**PB# 94-13**

**Clean Earth**

**TOWN OF NEW WINDSOR  
PLANNING BOARD  
REVIEW COMMENTS**

**REVIEW NAME:** CLEAN EARTH OF NEW YORK SITE PLAN AMENDMENT  
**PROJECT LOCATION:** MERTES LANE  
SECTION 68-BLOCK 2-LOT 2.1  
**PROJECT NUMBER:** 94-13  
**DATE:** 28 SEPTEMBER 1994  
**DESCRIPTION:** THE APPLICATION INVOLVES A PROPOSED AMENDMENT  
TO THE PREVIOUSLY APPROVED SITE PLAN. THE  
APPLICATION WAS PREVIOUSLY REVIEWED AT THE  
8 JUNE 1994 AND 14 SEPTEMBER 1994 PLANNING BOARD  
MEETINGS.

Patrick T. Kennedy, L.S.  
219 Quassaick Ave. New Windsor, New York 12553  
SCALE 1" = 50' DATE Sept. 1/94  
DRAWN BY  
DRAWING NUMBER 41-1167A

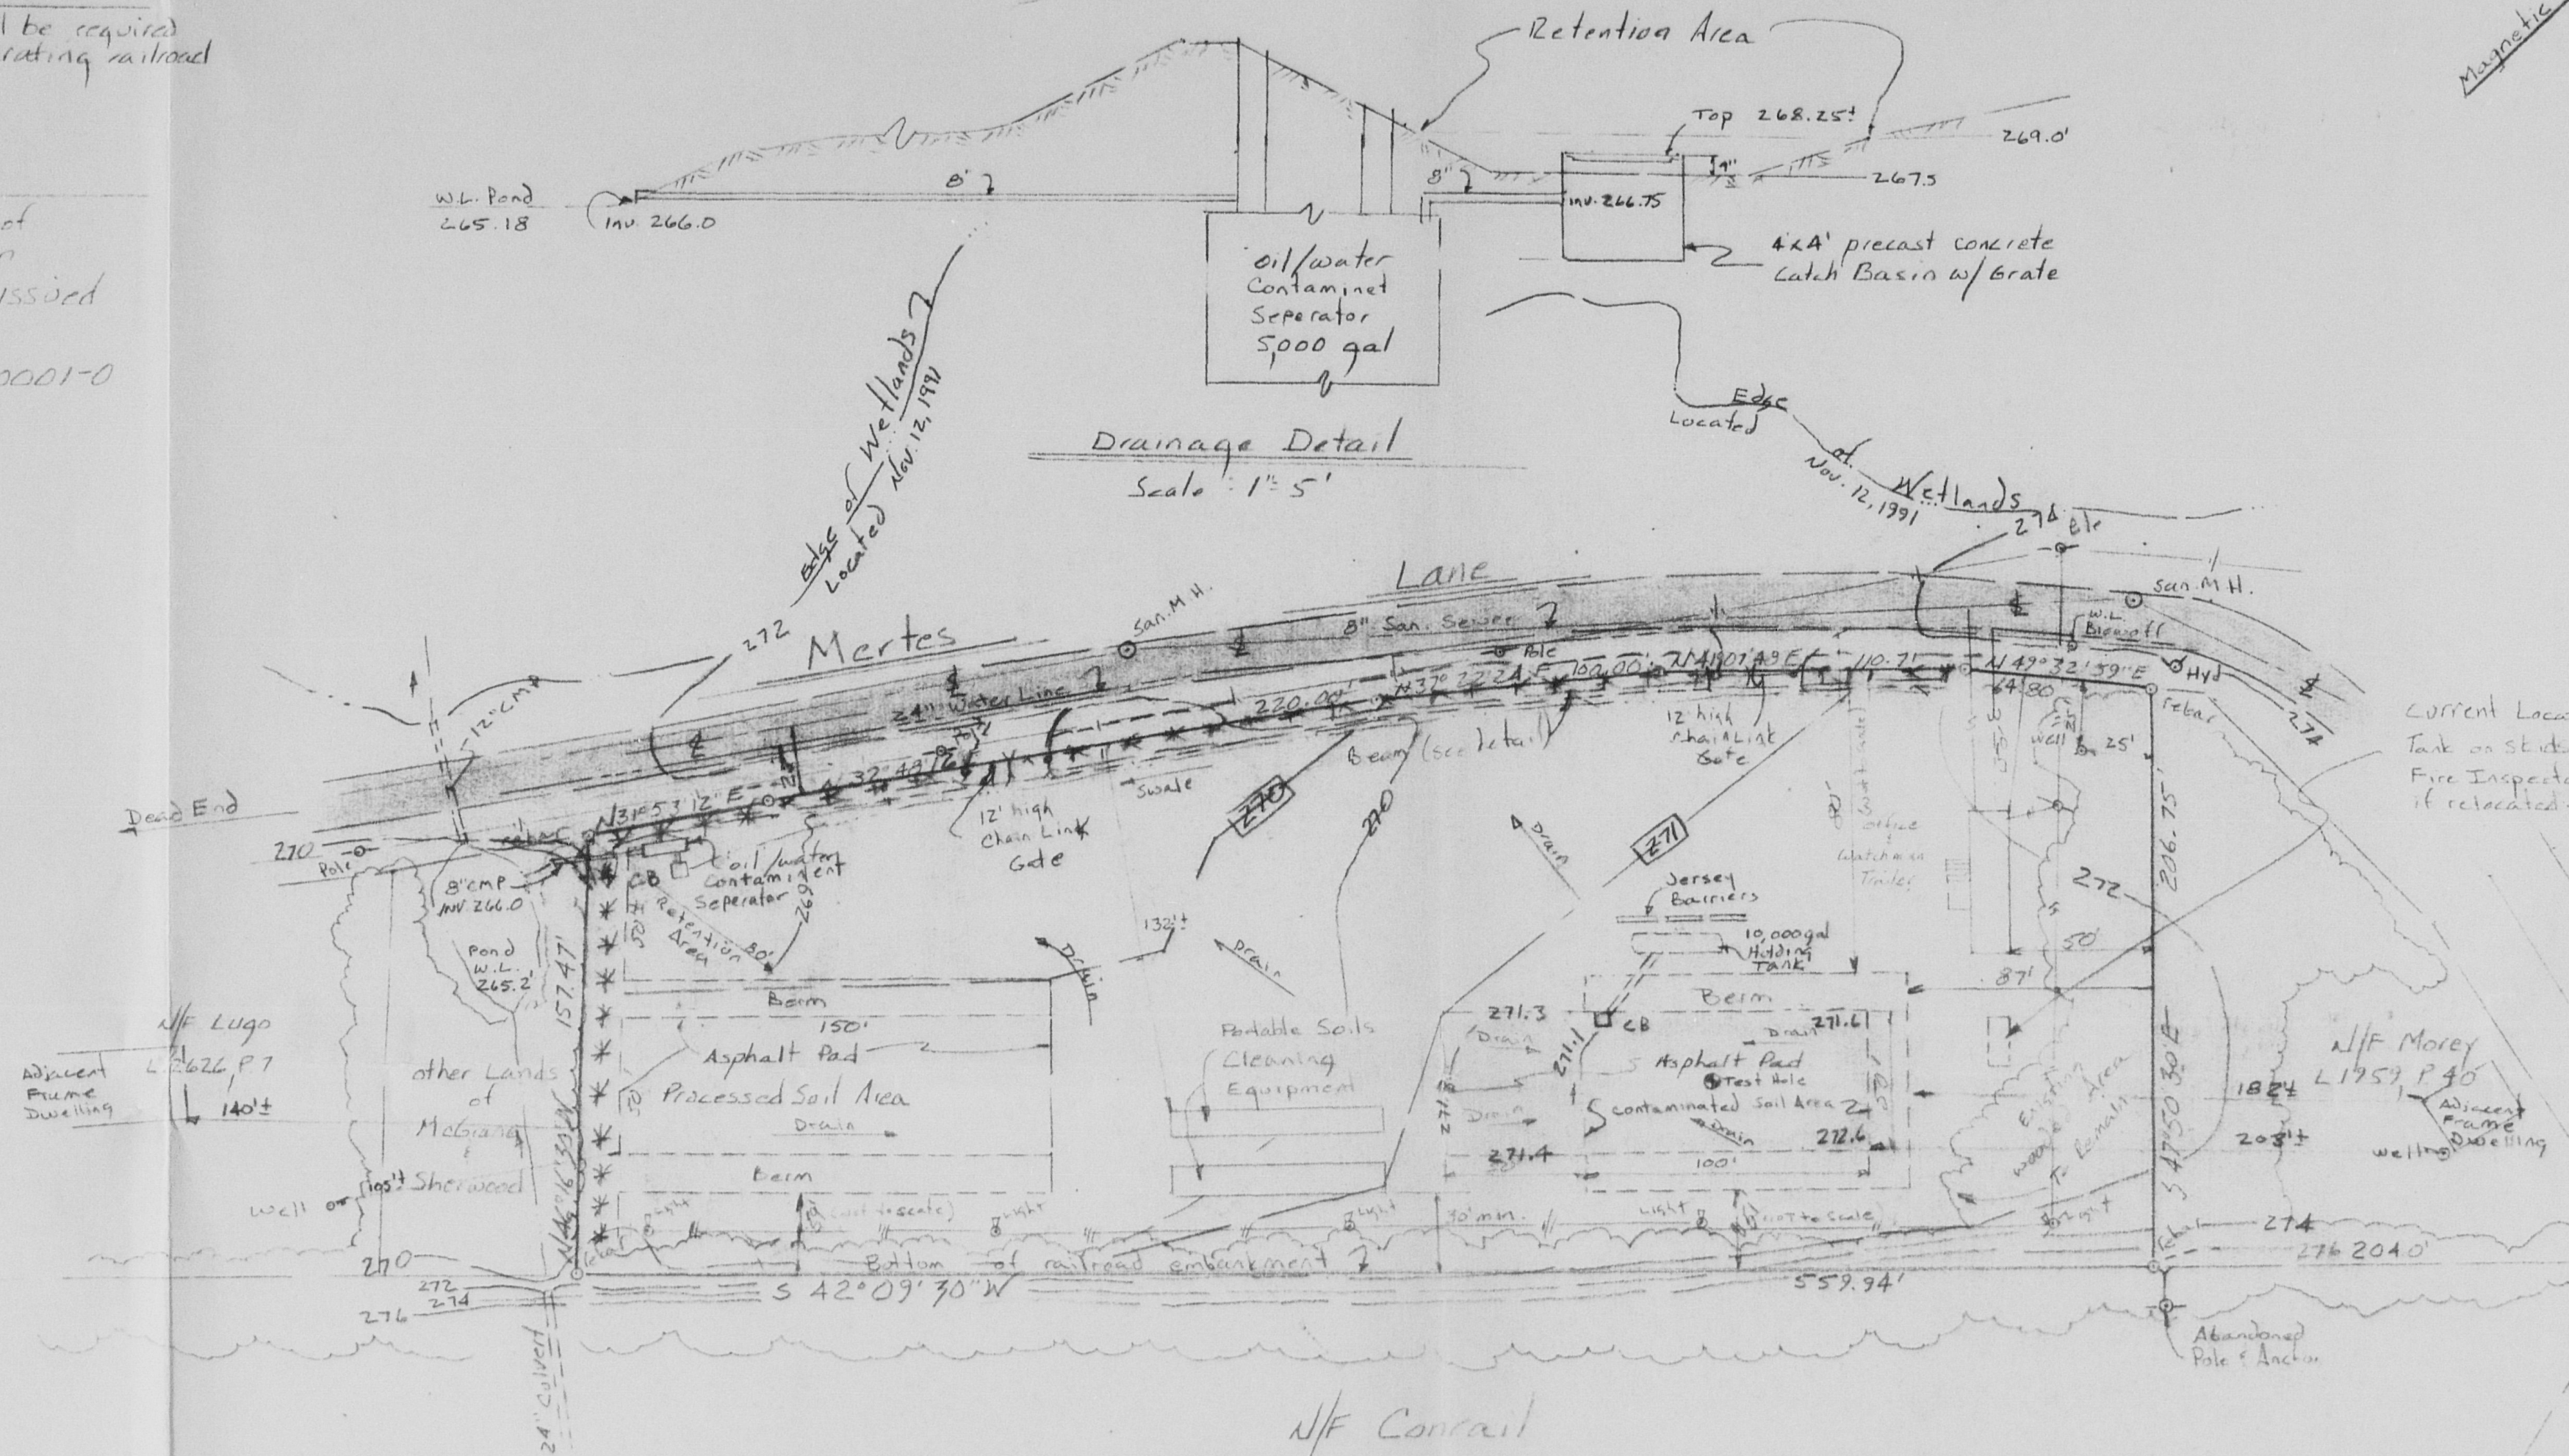
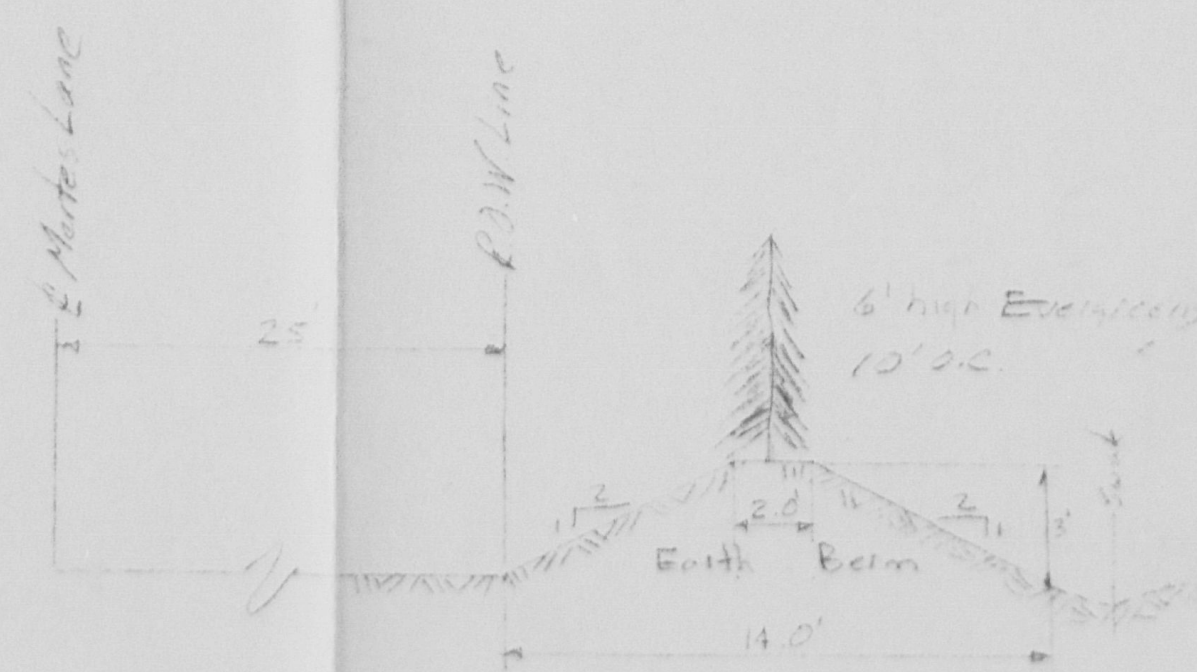
1. The property is located within the PI Zoning District. The Application indicates classification as Use A-15, a use permitted by right. The required bulk information shown on the plan appears correct for the zone and proposed use.
2. Previously, it was my concern that the proposed building required a variance for building height based on the proposed location. The new plans indicate a rear yard setback from the new proposed building as 51 feet (shown not to scale on the drawing). Based on this rear yard setback, the proposed building of 24 foot height would be acceptable and no variance would be necessary.

The plan should also indicate that the setback of the proposed building from the front yard is also shown not to scale.

The bulk table on this plan has not been revised. Further, the Board should determine, for the record, whether they believe a referral to the ZBA is required.

2. The Applicant has added the location of the diesel fuel tank onto the plans and, as well, the "office and watchman trailer" has been relocated to the north.

MR. EDSALL: For the front dimension, which is not to scale, you show that one not to scale as well, that is my suggestion. Obviously, that is not a serious issue. They've resolved the serious issue, question of whether or not they need a variance. Based on what Pat is now

MR. EDSALL: As far as I can see, there's no required building height number provided from what is on the table, just says 6 inch to the nearest lot line, it should be computed and I would assume if I understand the plan correctly, that would allow a 15 foot height. If that is the case, this shows 32 1/2. So I would think you have to make some adjustments and make it comply.
